SIL 752

# Service Information Letter

Units Affected: Certain AT48S and AT48M aerial devices  
built from January 2017 through August 2019 (see attached list)

## HuckBolt and U-Bolt Inspection

**Figure 1 — Orientation of Shear Plate Bolts**

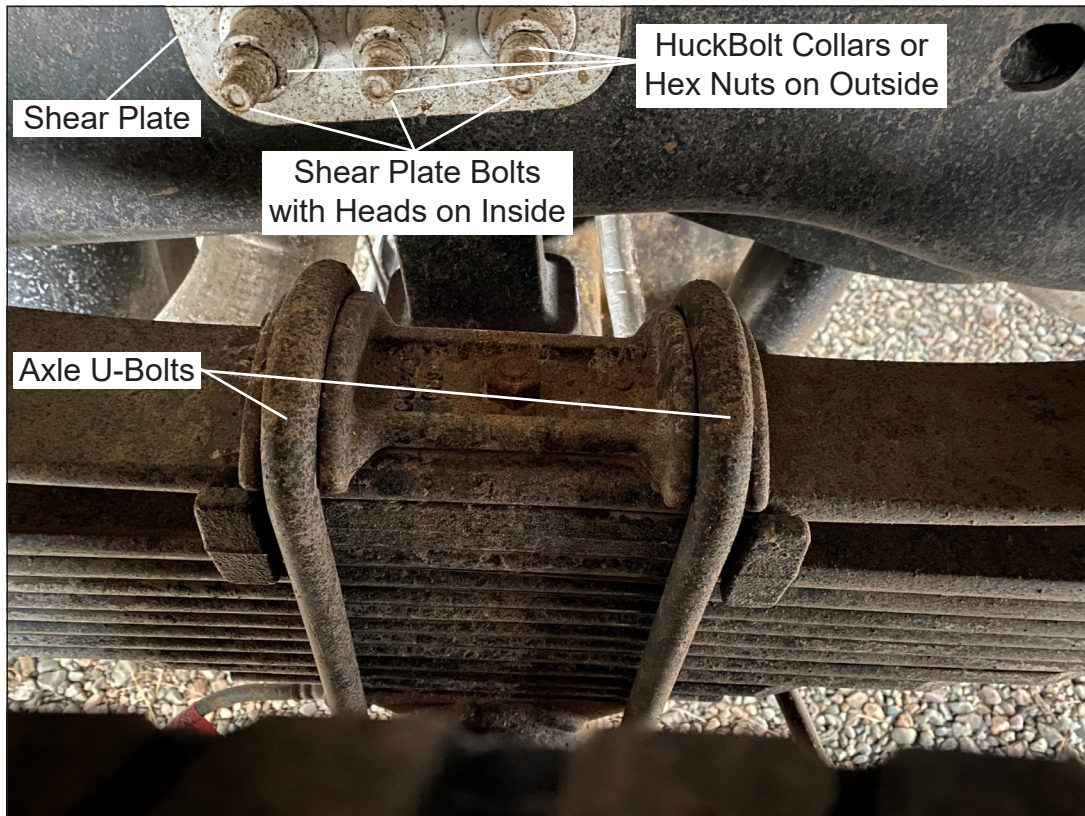
1. Position the unit on a level surface, apply the parking brake, and chock the wheels. Turn off the engine and remove the key from the ignition.
2. Look at the location and orientation of the bolts in the shear plate above the rear axle on both sides of the chassis (refer to Figure 1).

- If all the shear plate bolts are installed with the heads on the outside, the clearance is adequate. Proceed to step 10.
  - If any of the shear plate bolts are installed with the collar or hex nut located on the outside, inspect for the location of the shear plate bolts vs. the rear axle U-bolts.

**Figure 2 — Shear Plate Bolts Located Above Axle U-Bolts**

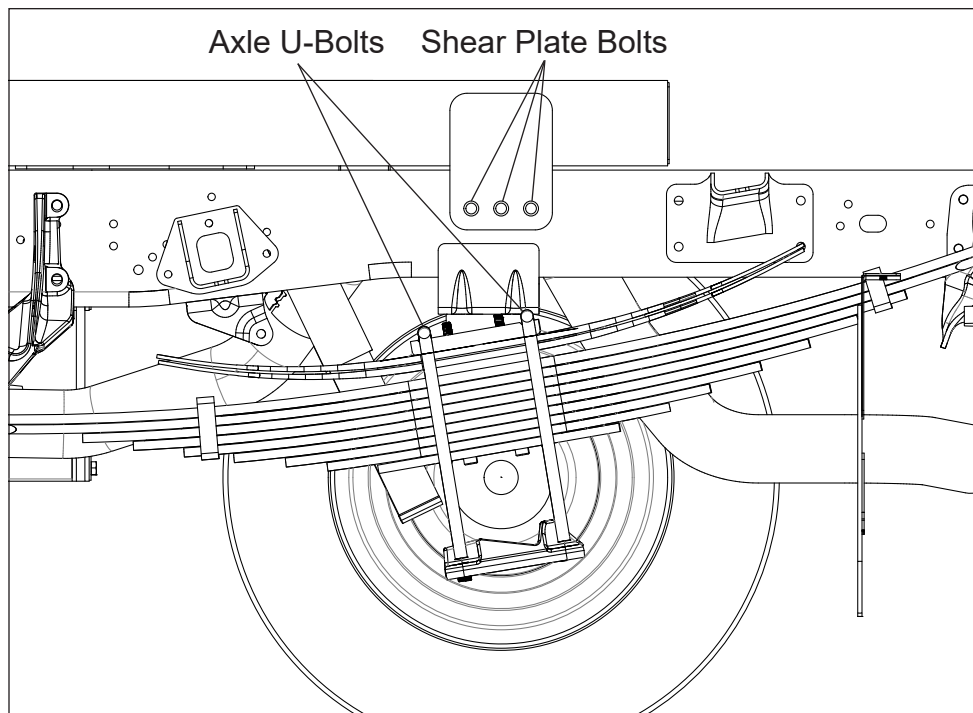
- If any of the shear plate bolts are located in the region directly above the top of either axle U-bolt (refer to Figure 2), proceed to step 3.
    - If the frontmost shear plate bolt is located with a horizontal spacing of 1" or more behind the top of the rearmost axle U-bolt (refer to Figure 3), the clearance is adequate. Proceed to step 10.

**Figure 4 — Shear Plate Bolts Located in Front of Axle U-Bolts**

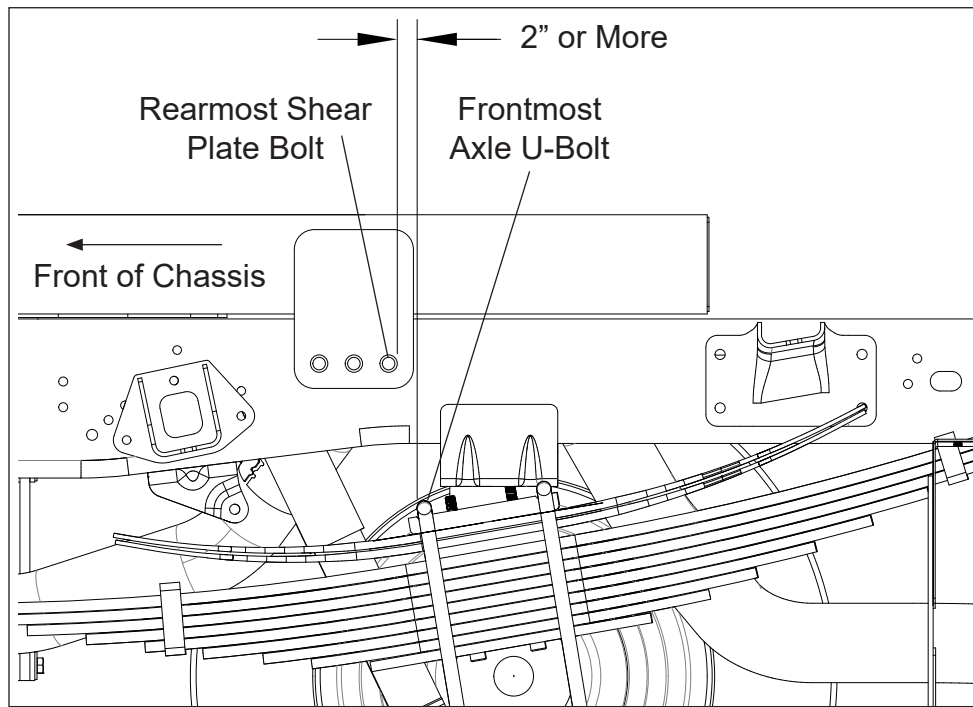
- If the rearmost shear plate bolt is located with a horizontal spacing of 2" or more in front of the top of the frontmost axle U-bolt (refer to Figure 4), the clearance is adequate. Proceed to step 10.

**Figure 9 — Identifying Shear Plate Bolt to Measure for Clearance**

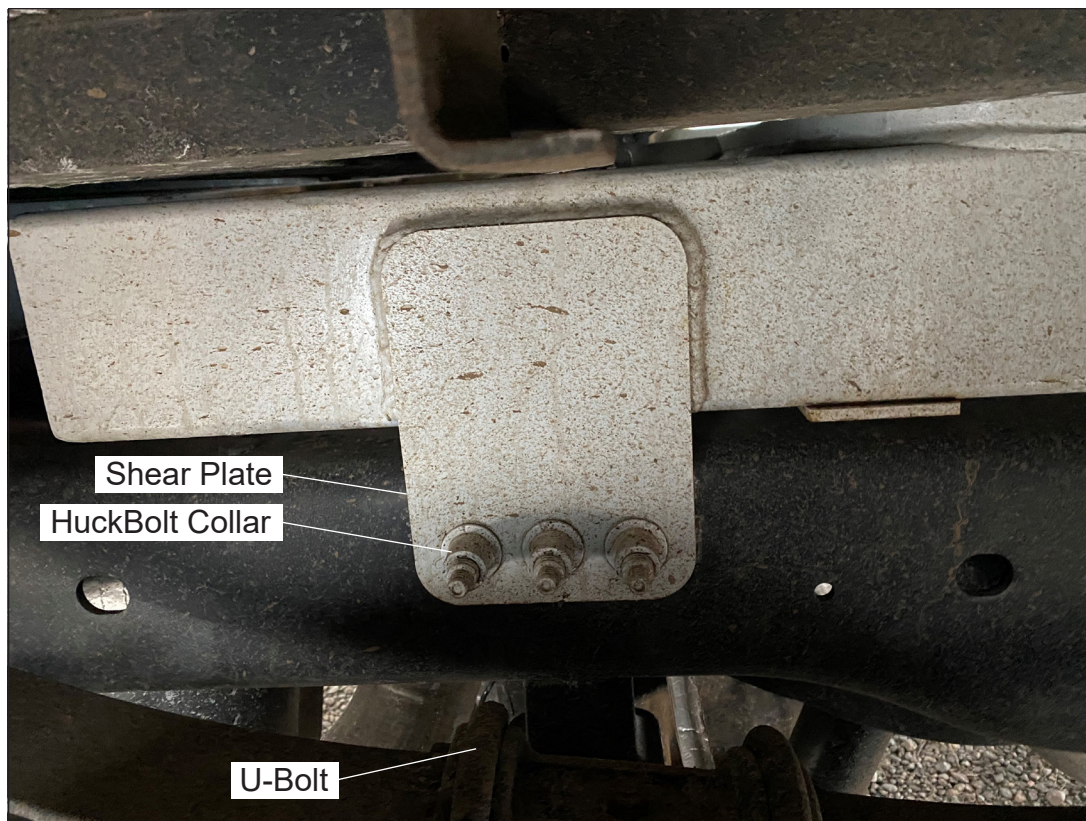
5. Identify a HuckBolt collar or hex nut located above one of the rear suspension U-bolts on the street side of the chassis (refer to Figure 9). Measure the vertical distance from the top of the U-bolt to the bottom of the collar or hex nut (refer to Figure 10). Subtract  $\frac{1}{2}$ " as a safety factor to determine the U-bolt clearance number. Enter this number in column B of the table in Figure 8.
- For example, if the vertical distance measurement is 5", calculate  $5" - \frac{1}{2}" = 4\frac{1}{2}"$  for the U-bolt clearance number.

**Figure 11 — Inspecting U-Bolt for Damage**

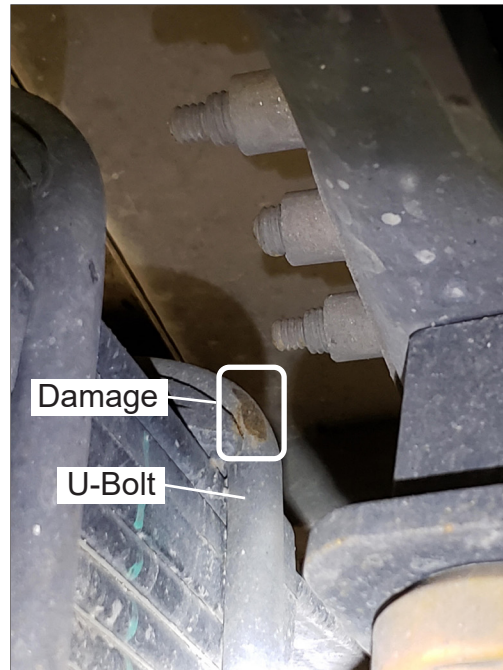
8. Look at the top portion of a street side U-bolt that can potentially contact a shear plate bolt end, collar, or hex nut. Clean off any dirt or debris on the portion of the U-bolt below the shear plate bolt using an appropriate method, to ensure that any existing damage to the U-bolt will be visible. Using a flashlight, if necessary, inspect the U-bolt for damage due to contact with the shear plate bolt end, collar, or hex nut (refer to Figure 11). Repeat this inspection for the second street side U-bolt if it can also potentially contact a shear plate bolt end, collar, or hex nut.

9. Repeat step 8 for the curb side.
10. Proceed based on the inspection results.
  - If the clearance is adequate, no replacement kit(s) are required. Complete the Inspection Sheet at the end of this SIL and return it to Altec. Return the unit to service.
  - If the clearance is not adequate, take the unit out of service. Order and schedule the installation of the required replacement kit(s) based on the inspection results. Each kit contains parts for one side of the chassis. If parts are needed for both sides, two kits are required. Do not submit the Inspection Sheet at the end of this SIL.

- If no damage is found on any U-bolts, order only the HuckBolt replacement kit(s).
- If U-bolt damage is found on a Dodge chassis, order the HuckBolt replacement kit(s) plus the Dodge chassis U-Bolt replacement kit(s).
- If U-bolt damage is found on a Ford chassis, order the HuckBolt replacement kit(s) plus the Ford chassis U-Bolt replacement kit(s).
